Contract #: 04-0120F4Cty: SF/ALA Rte: 80 PM: 13.2/13.9File #: 69.25B**QUALITY ASSURANCE -- NON-CONFORMANCE REPORT****Location:** Changxing Island, Shanghai, P.R. China**Report No:** NCR-000607**Prime Contractor:** American Bridge/Fluor Enterprises, a JV**Date:** 06-Jan-2010**Submitting Contractor:** Zhenhua Port Machinery Company, Ltd (ZPMC), Changxing Island**NCR #:** ZPMC-0580**Type of problem:**

**Reference Description:** ZPMC welded a FCAW single pass weld bead wider than the allowed specification**Description of Non-Conformance:**

**Subject:** NCR No. ZPMC-0580

**Job Name:** SAS Superstructure

**ZPMC**  
 ZHEJIANG ZHONGYUAN PORT MACHINERY CO., LTD.  
 WELDING MAP  
 SHIP DRAWING FILE: BK004A6  
 PAQUINTURE: 1/1

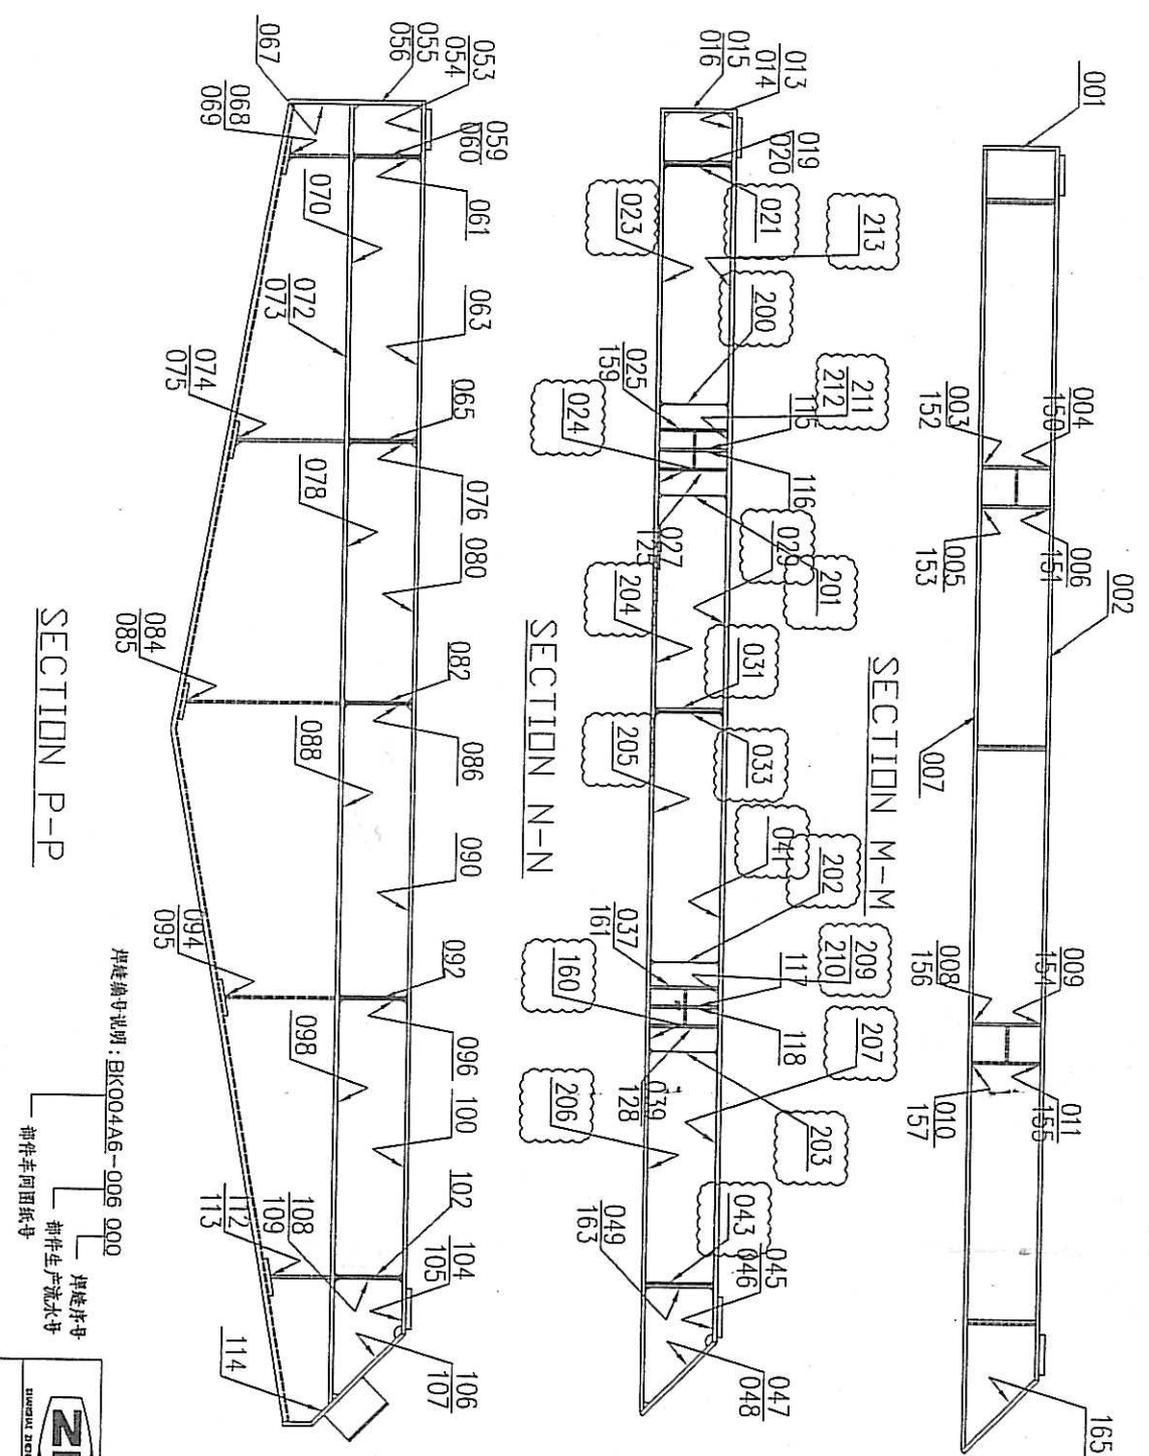
ZPMC is providing the NDT record to show the soundness of this weld. Please be noticed, ZPMC has revised the weld ID to be BK004A6-006-031. Based on this, ZPMC is requesting closure of this NCR.
